In reply, please  
refer to LAC-8629

DOCKET NO. 50-409

SUBJECT: DAIRYLAND POWER COOPERATIVE  
LA CROSSE BOILING WATER REACTOR (LACBWR)  
PROVISIONAL OPERATING LICENSE NO. DPR-45  
APPLICATION FOR AMENDMENT TO LICENSE

FIGURE 1 EFFECT OF NEUTRON FLUENCE ON REDT OF LACBWR VESSEL SURVEILLANCE MATERIALS

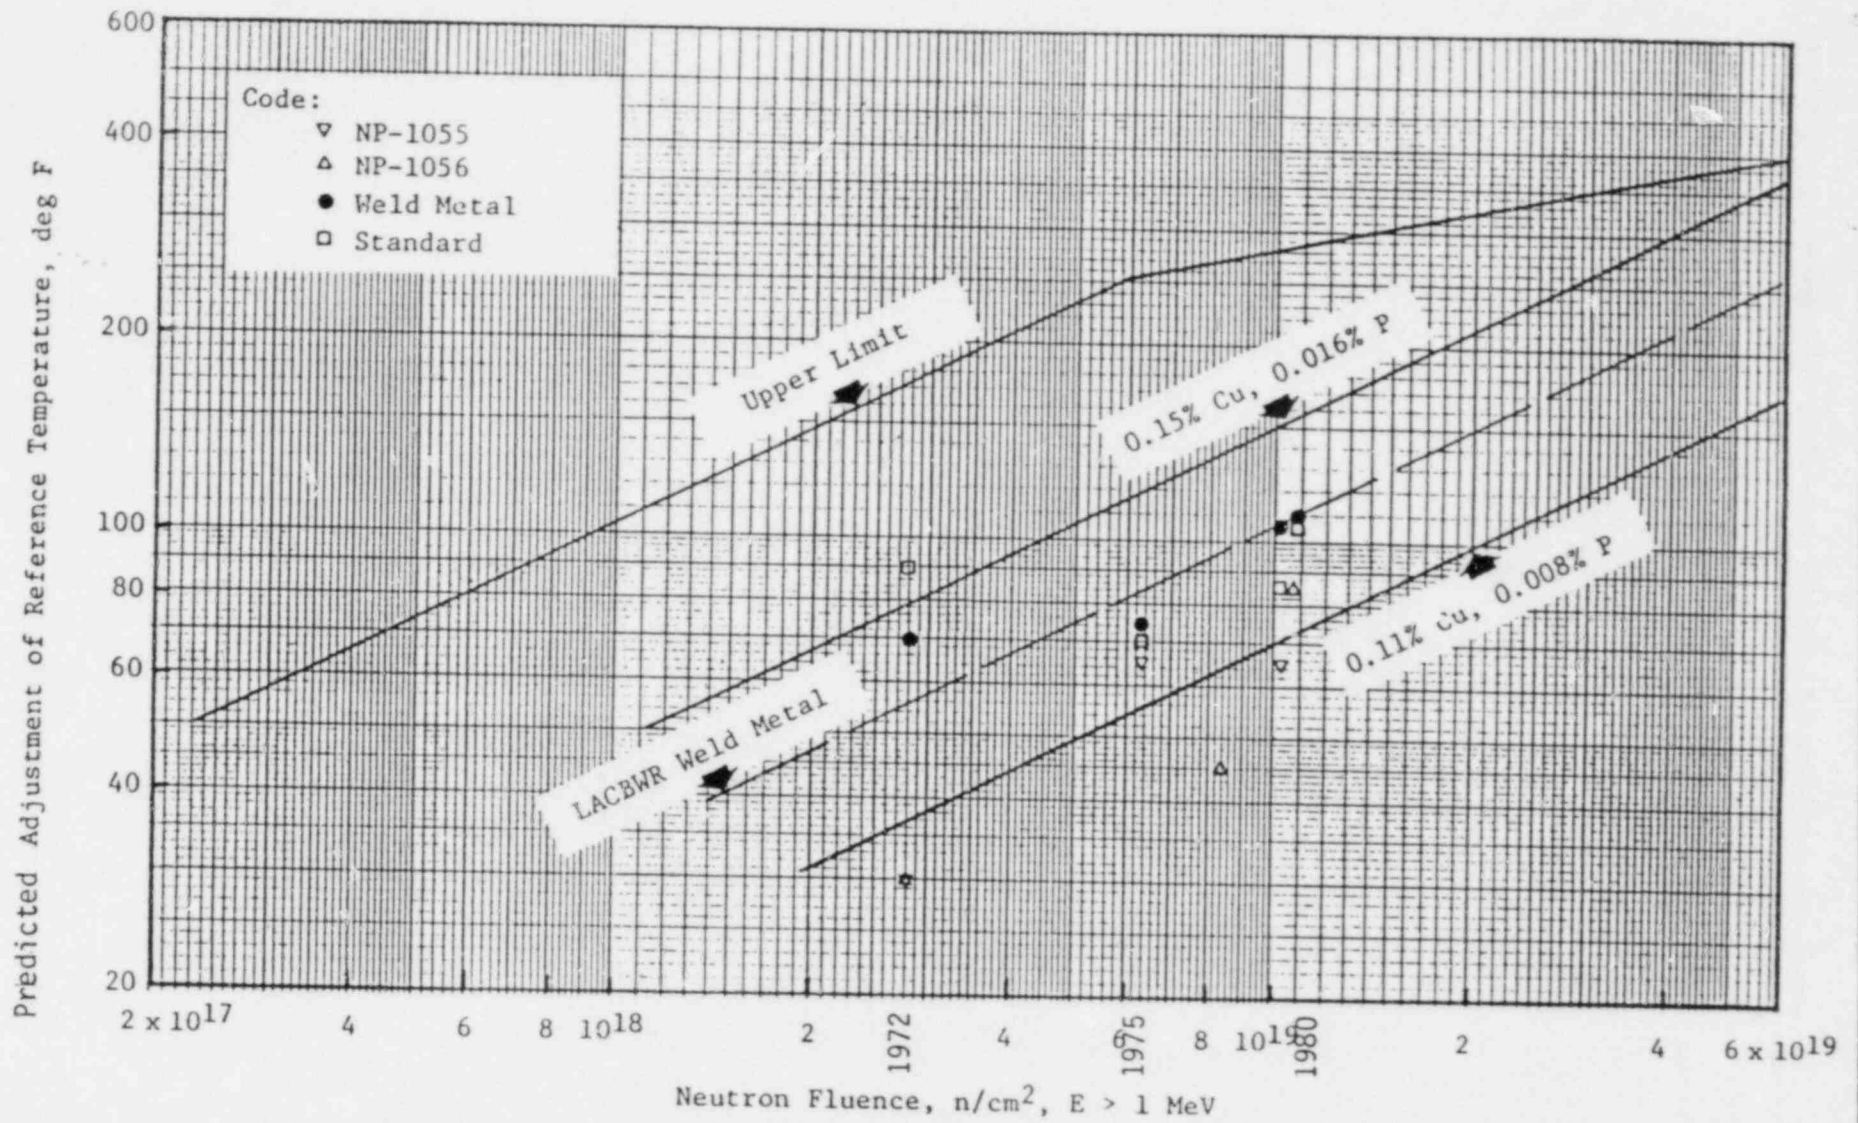
The third set of reactor vessel surveillance capsules was removed from the LACBWR vessel during the 1980 refueling outage. The neutron flux results and the neutron embrittlement responses of the surveillance materials, although in good agreement with data from previous analyses, did indicate that the rate of embrittlement is less than previously projected. Table 1 shows the results of tests performed to determine the initial  $RT_{NDT}$ . A comparison of the predicted  $RT_{NDT}$  shift, based on fluence and initial copper content, to surveillance capsules analyzed is shown in Figure 1. A detailed report of the test results of the surveillance specimens is contained in Reference 2.

Replace Section 4.2.2.4 a through e with the enclosed proposed LCO 4.2.2.4 and associated surveillance requirements. Figure 5 on Page 30b of present Technical Specifications remains the same, although it is enclosed herein, in a more readable condition as Figure 4.2.2.4-1. Figure 6 on Page 30c is replaced by the enclosed Figure 4.2.2.4-2. This figure is updated, based on Reference 2 data.
